Ground Floor Strategy

Consented Scheme

Revised Scheme

Revised Scheme - First Floor Plan

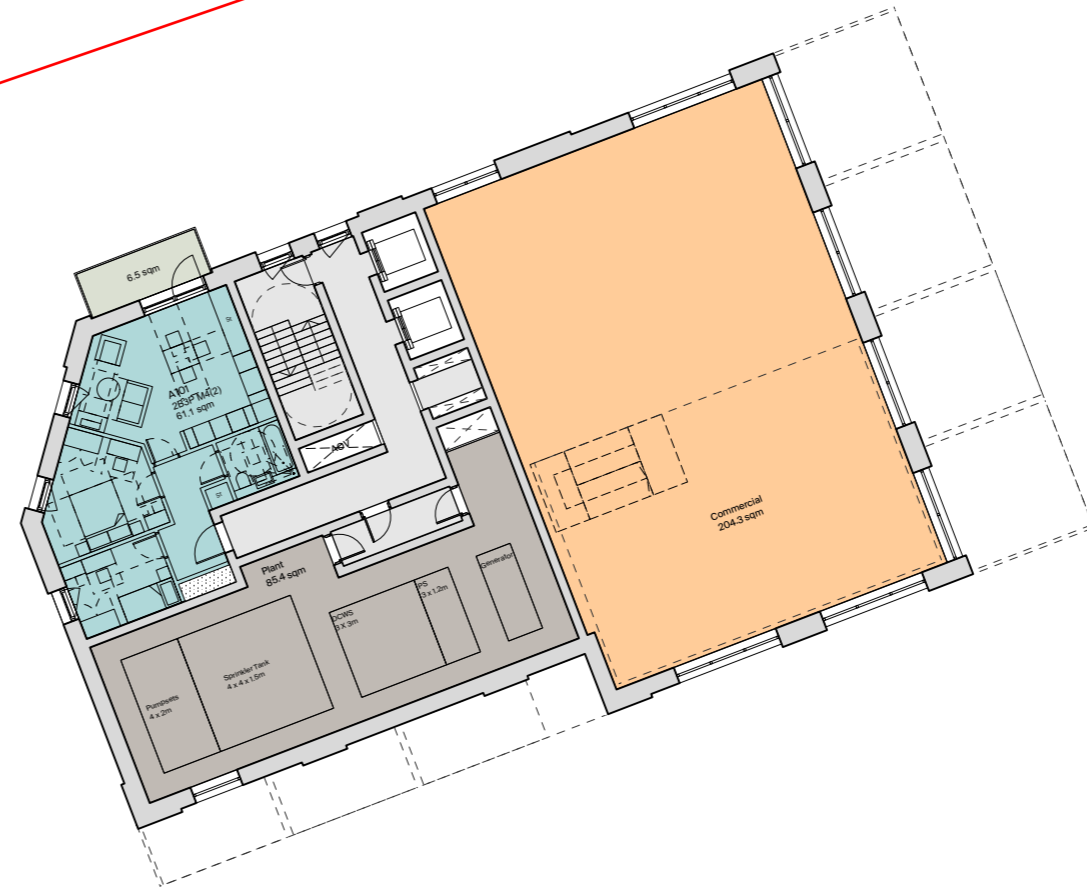
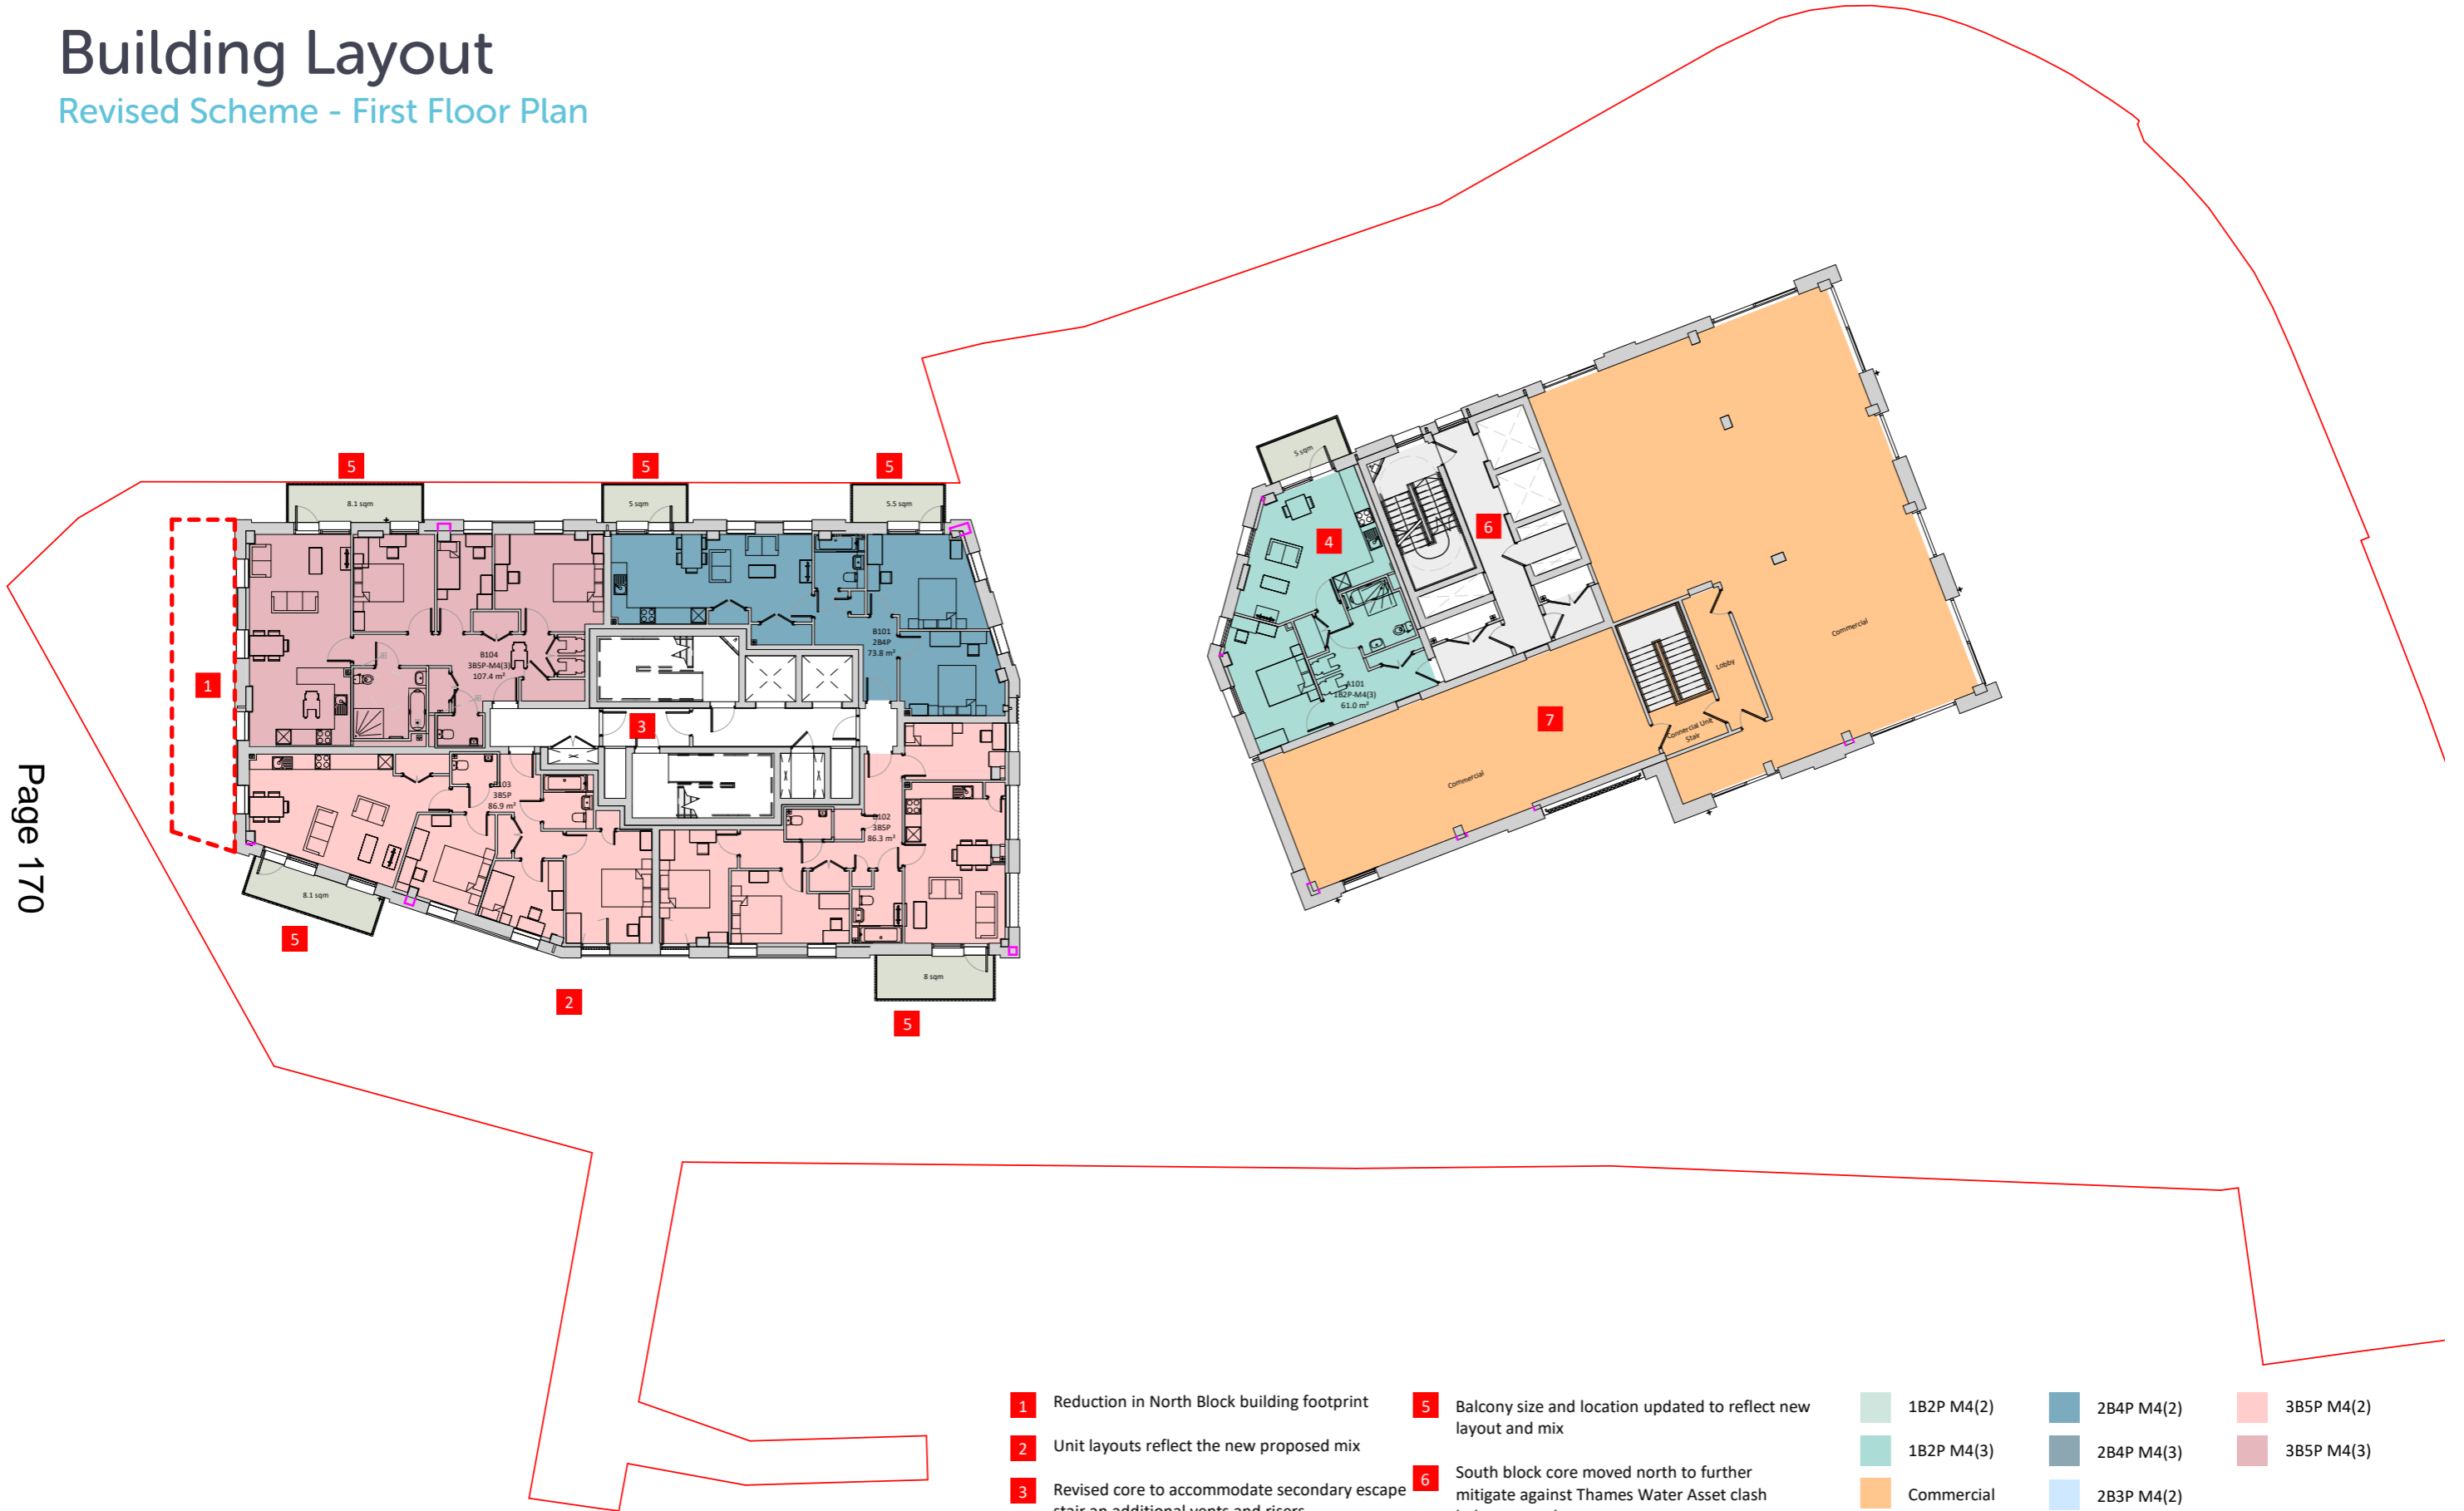
| 1 Reduction in North Block building footprint | 5 Balcony size and location updated to reflect new layout and mix | 1B2P M4(2) | 2B4P M4(2) | 3B5P M4(2) |
| 2 Unit layouts reflect the new proposed mix | 6 South block core moved north to further mitigate against Thames Water Asset clash below ground | 1B2P M4(3) | 2B4P M4(3) | 3B5P M4(3) |
| 3 Revised core to accommodate secondary escape stair an additional vents and risers | 7 Plant room moved to ground level and replaced with Commercial space | Commercial | 2B3P M4(2) | |
| 4 Revised WA 1b2p unit layout | | | | |

Revised Scheme - Second to Third Floor Plan

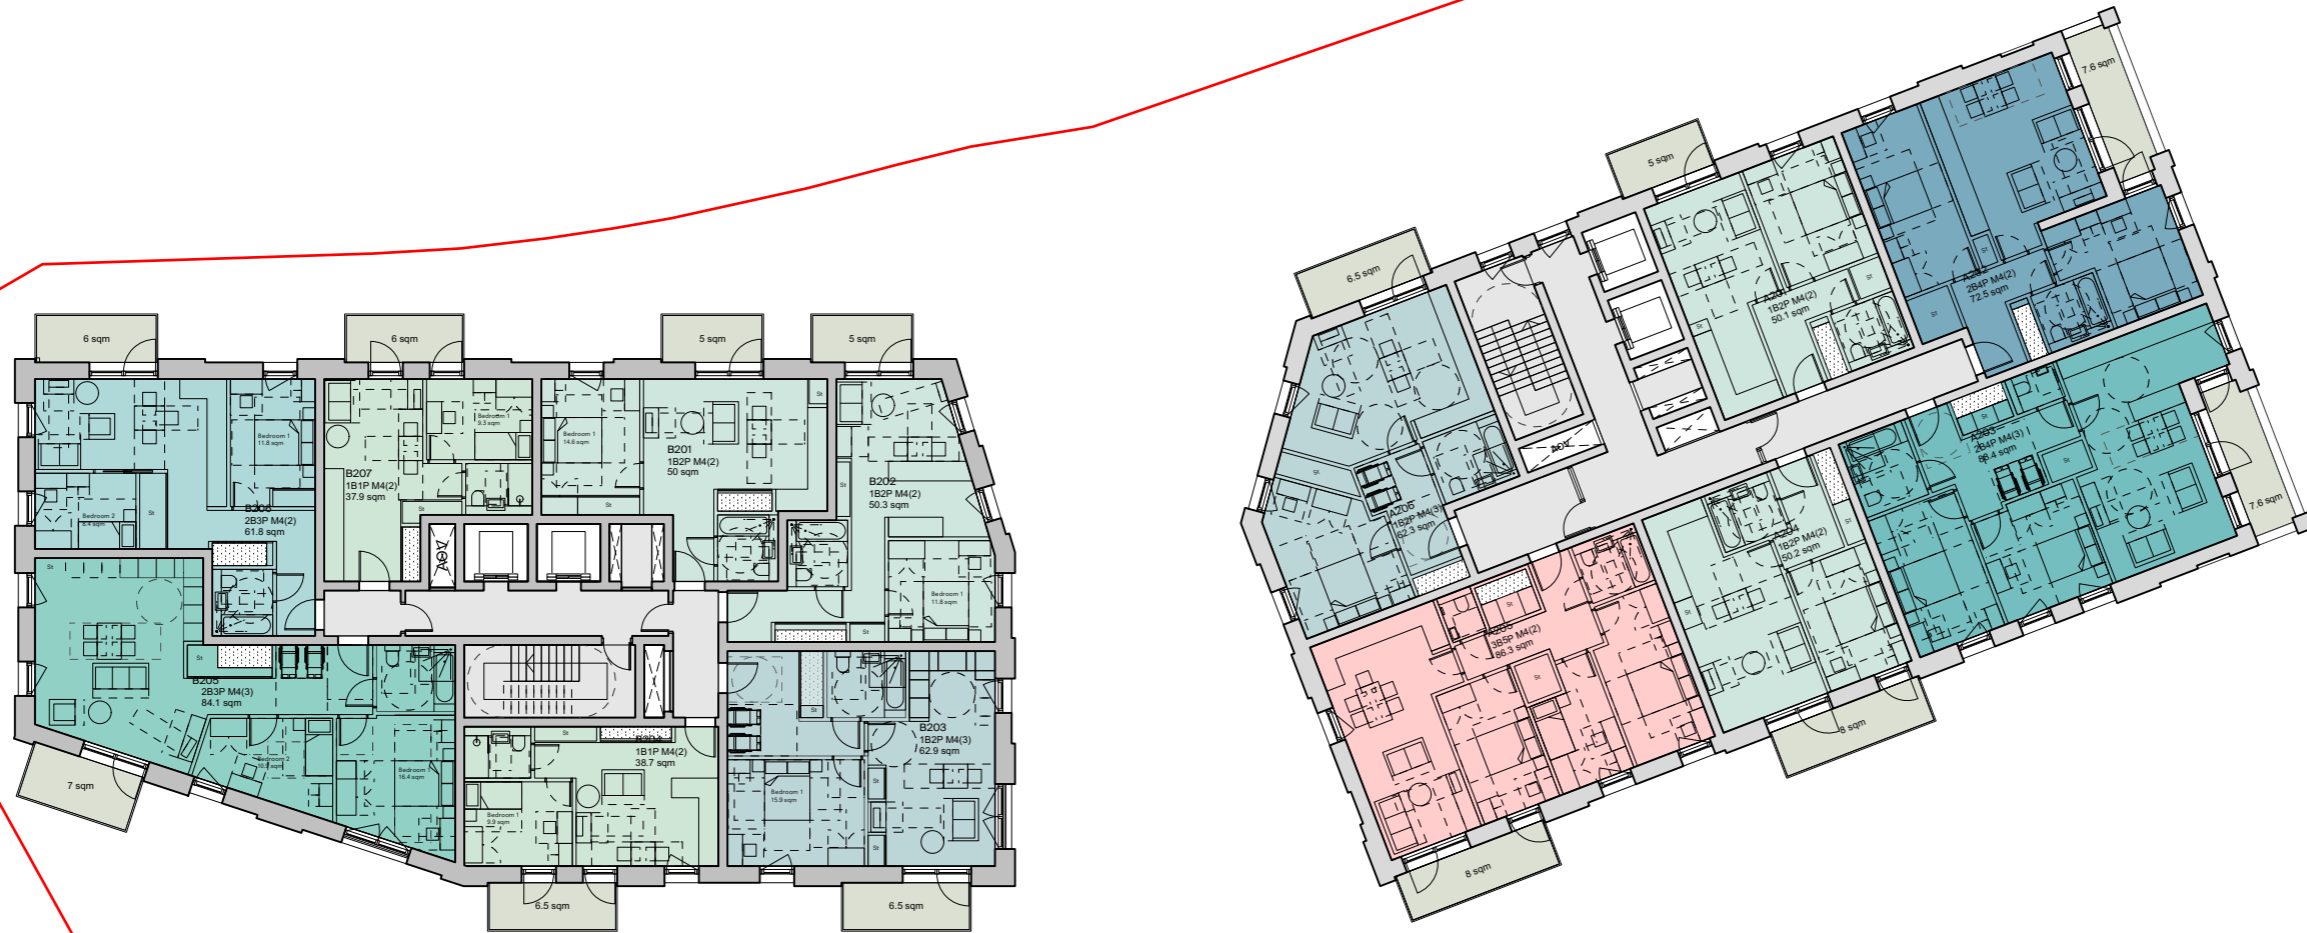
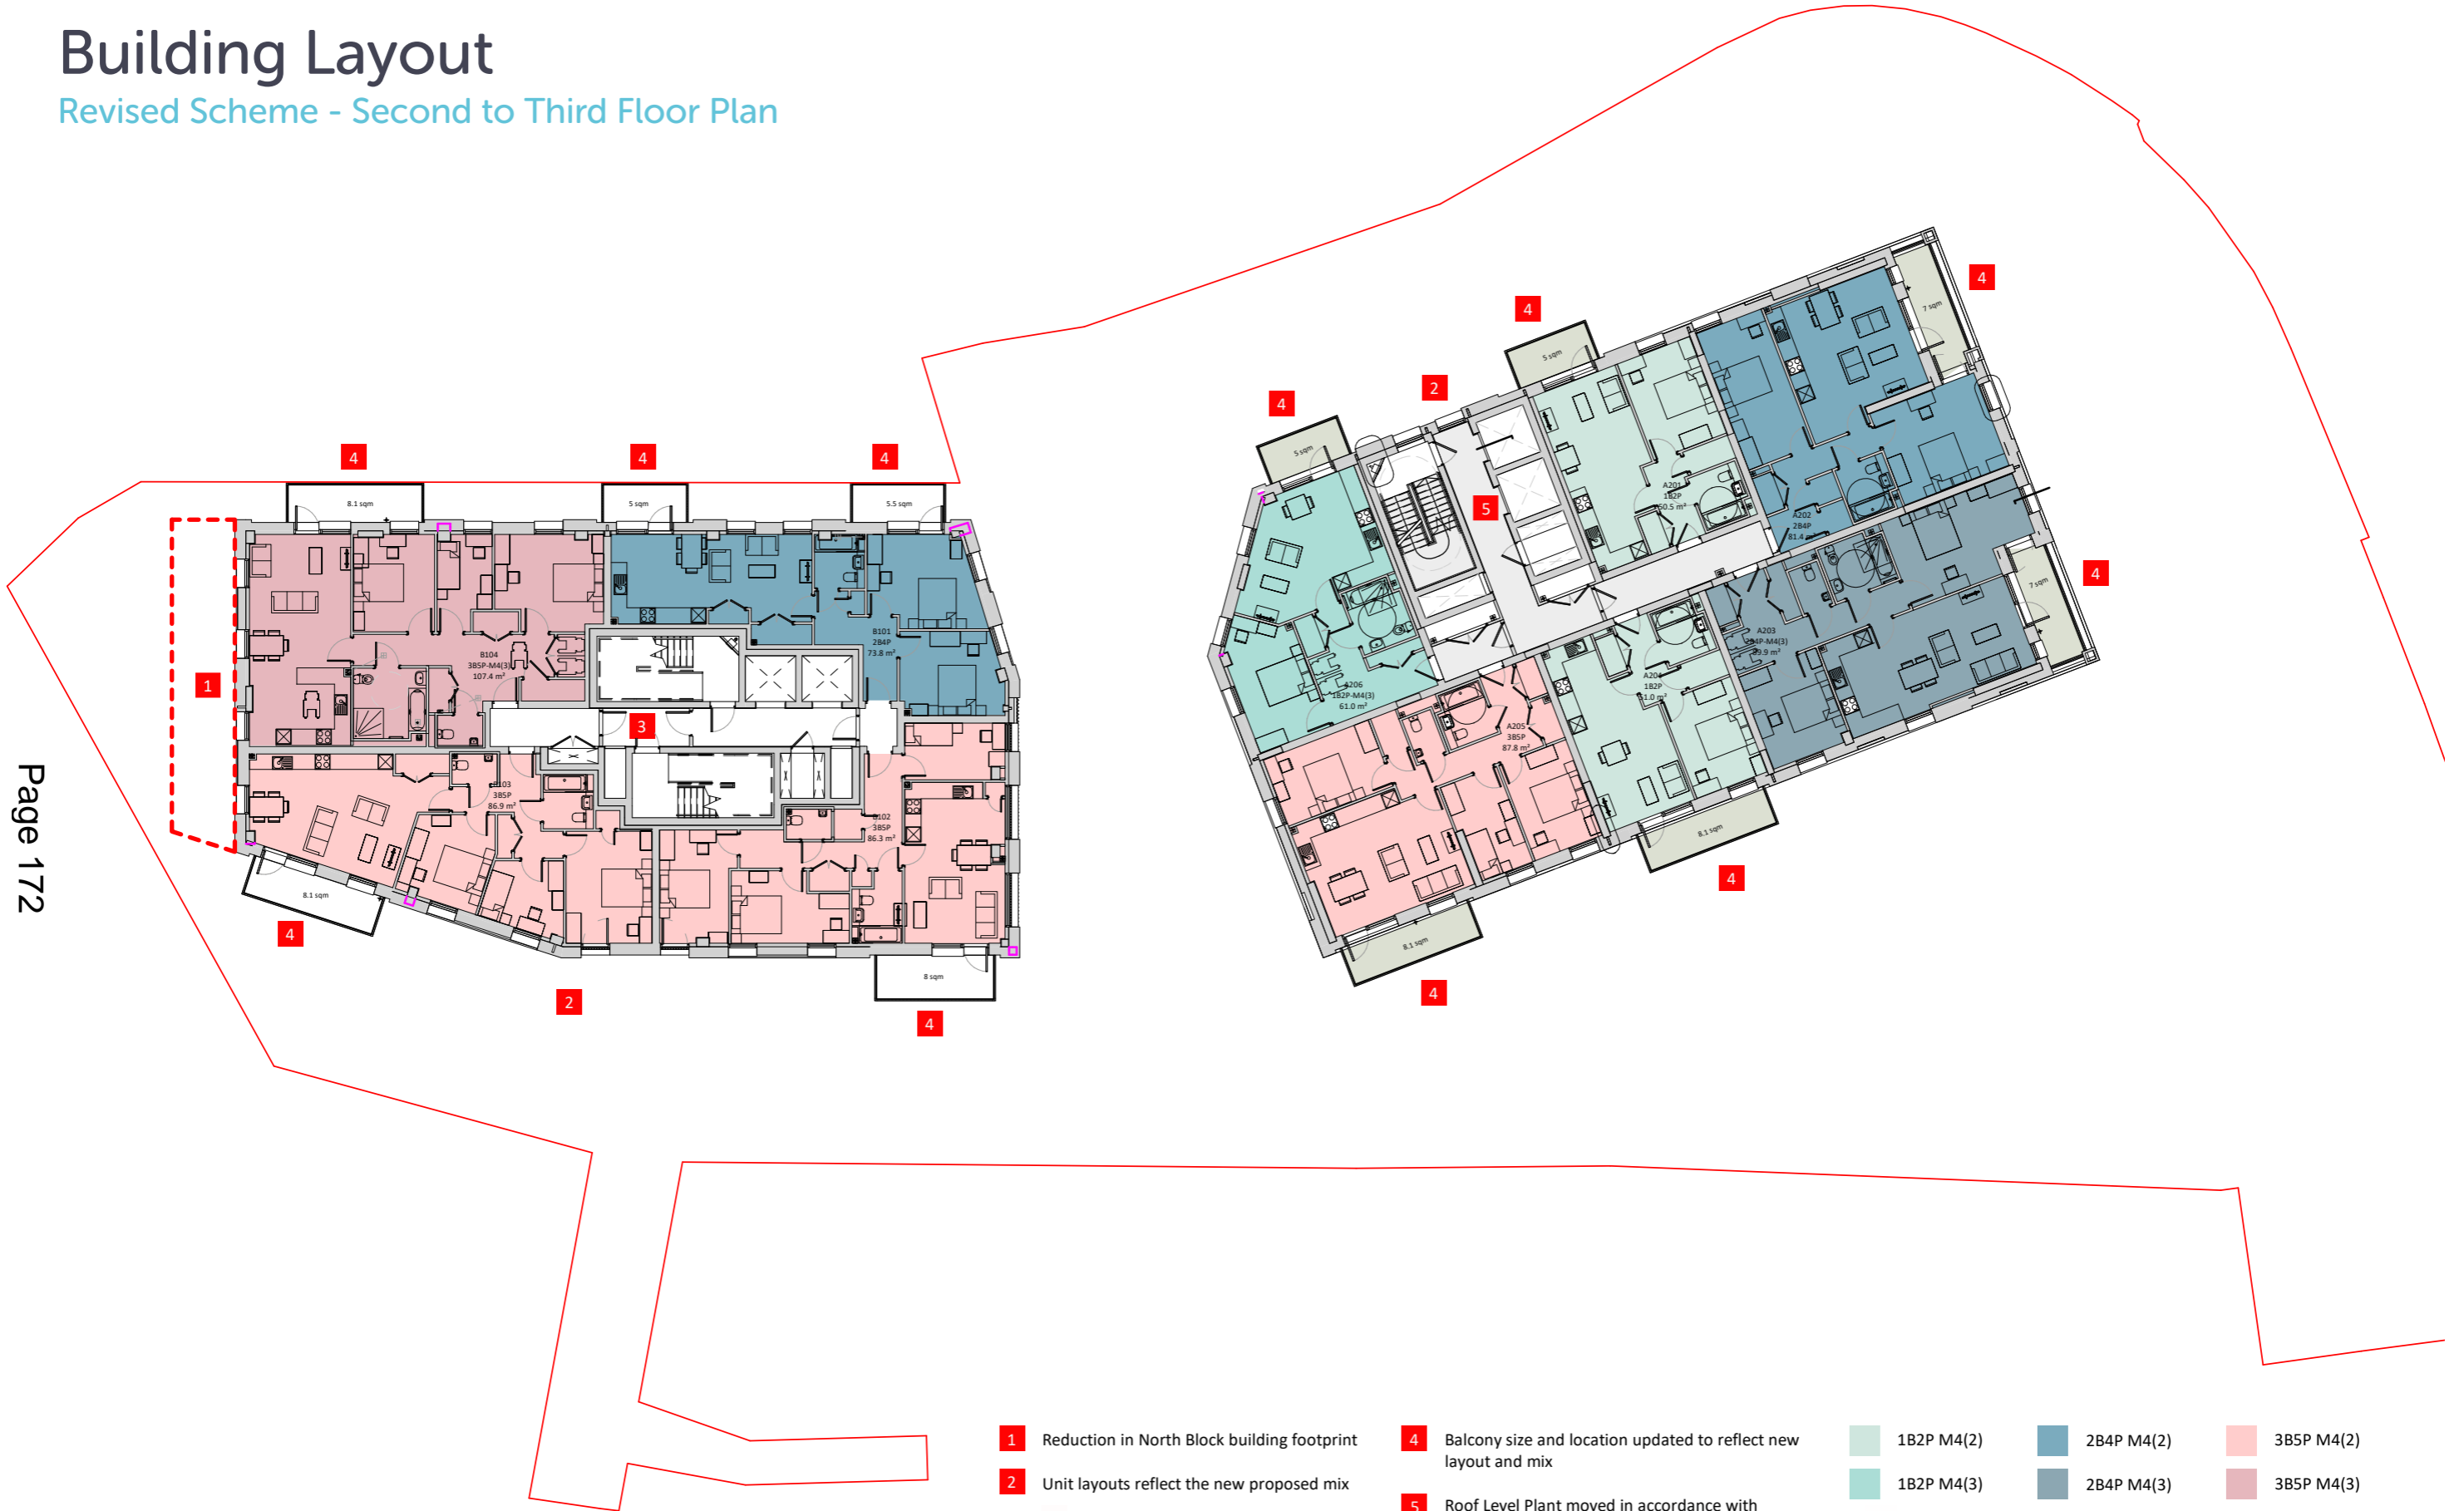
| 1 Reduction in North Block building footprint | 4 Balcony size and location updated to reflect new layout and mix | 1B2P M4(2) | 2B4P M4(2) | 3B5P M4(2) |
| 2 Unit layouts reflect the new proposed mix | 5 Roof Level Plant moved in accordance with below core shift | 1B2P M4(3) | 2B4P M4(3) | 3B5P M4(3) |
| 3 Revised core to accommodate secondary escape stair and additional vents and risers | | | 2B3P M4(2) | |
